October 9, 2023

To: City of Albuquerque Planning Department
Plaza del Sol Building
600 Second NW
Albuquerque, NM 87102

Re: Starbucks
Project #: PR-2023-008767
Application #: SI-2023-01512

Please find the following responses addressing comments received in a letter dated October 4, 2023. In an effort to address your comments concisely and simplify your review of these development plans, we have summarized your comments and our responses below. Your comment is listed first, followed by the response in Bold.

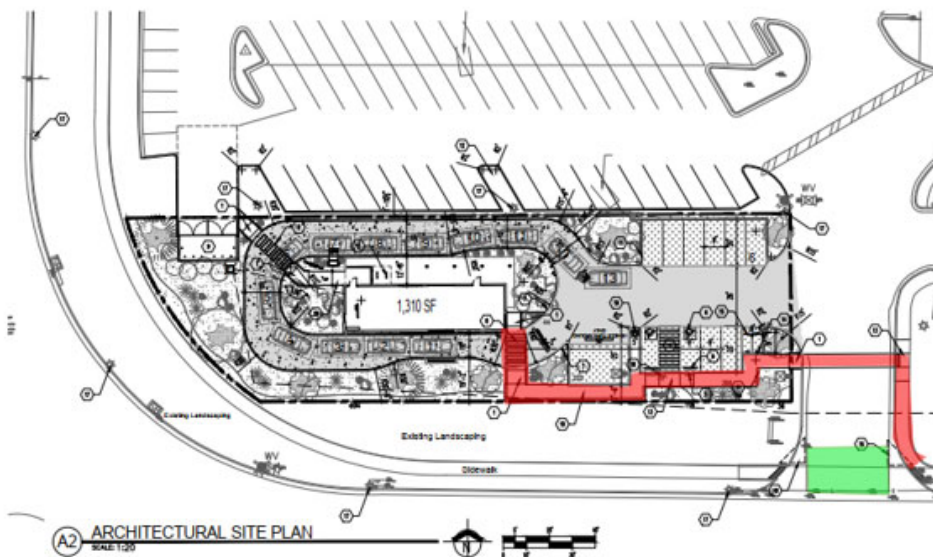
14-16-5-3(D)(3)(b)(3) On site pedestrian path ways from the Wenonah Ave street side and pathway from the north side parking area. Not the driveway area

Applicant Response: A pedestrian path is being provided from the Wenonah. See below on how the path in being provided (shown in red). It was determined the best path because the existing grades that exist on site.
